3. COMMENT DOCUMENTS AND RESPONSES

Oak Ridge Site Specific Advisory Board
Recommendations and Comments
on the Draft Environmental Impact Statement
for Treating Transuranic/Alpha Low-Level Waste
at the Oak Ridge National Laboratory, Oak Ridge, Tennessee,
DOE-EIS-0305-D, February 2000

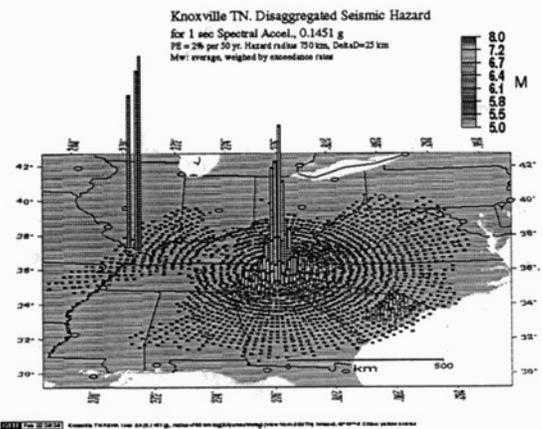
Figure 3-7 is completely confusing and the magnitudes are mixed. The caption says “Richter Scale,” the figure legend says “mb”. It is one or the other, but mb (body-wave magnitude) is correct but not very useful because it saturates at high magnitudes. The 1811 and 1812 earthquakes were nearly magnitude 8, but mb cannot measure that high. See Johnston (1996) for current discussion of the magnitude issue for New Madrid.

The caption for Figure 3-7 has been modified to delete any reference to “Richter Scale” to make figure data consistent with caption.
